Access Compliance Report

Public Rights-of-Way

(Curb Ramps)

Intersection ID: 30064	Main Street: CAMPUS_CONNECTION_DR	Cross Street: PAVILION_BV	Location: NE
ADA ID: 46B48CBDF29	Ramp Type: Perp	Initial Pass/Fail: Fail	Overall Compliance: No
Severity Score: 12.5			
Codes/Mitigation Info/Possible Solution		Field Measurements/Component Compliance

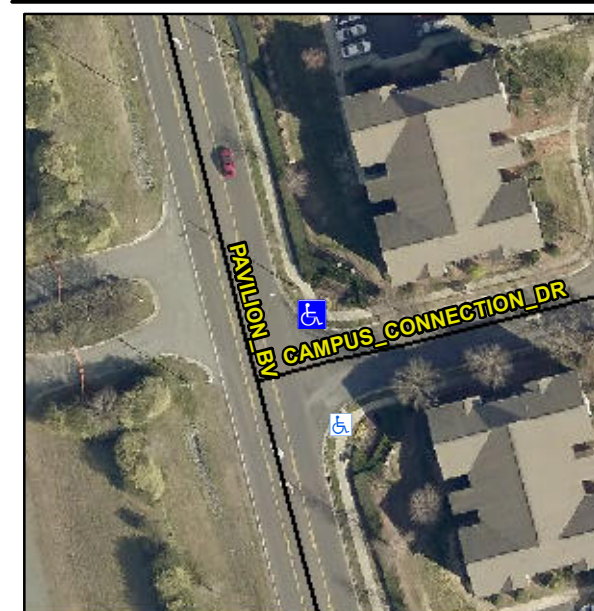
R304.2.2

Compliance	Description	Data	Compliance	Description	Data
N/A	Ramp Length (in)	53.0	No	Ramp Slope (%)	10.8
Yes	Ramp Width (in)	55.0	Yes	Ramp XSlope (%)	1.1
N/A	Flare Type LT	N/A	N/A	Flare Type RT	N/A
N/A	Flare Slope LT (%)	N/A	N/A	Flare Slope RT (%)	N/A
N/A	Flare Traversable LT?	N/A	N/A	Flare Traversable RT?	N/A
N/A	Landing Length (in)	N/A	N/A	DWS Provided?	N/A
N/A	Landing Width (in)	N/A	N/A	DWS Contrast?	N/A
N/A	Landing Slope (%)	N/A	N/A	DWS Length (in)	N/A
N/A	Landing X Slope (%)	N/A	N/A	DWS Full Width?	N/A
N/A	Landing Curb? (Y/N)	N/A	N/A	DWS Offset (in)	N/A
N/A	Shared Landing?	N/A			
N/A	Gutter Ponding?	N/A	N/A	Gutter Slope (%)	N/A
N/A	Gutter Lip Ht (in)	N/A	N/A	Gutter X Slope (%)	N/A
N/A	Painted X Walk1?	No	N/A	Painted X Walk2?	N/A
	X Walk 1 Direction	To S		X Walk 2 Direction	N/A
N/A	X Walk 1 Width (in)	N/A	N/A	X Walk 2 Width (in)	N/A
	X Walk 1 Slope (%)	3.9		X Walk 2 Slope (%)	N/A
	X Walk 1 X Slope (%)	0.4		X Walk 2 X Slope (%)	N/A

Remove & Replace Entire Ramp.
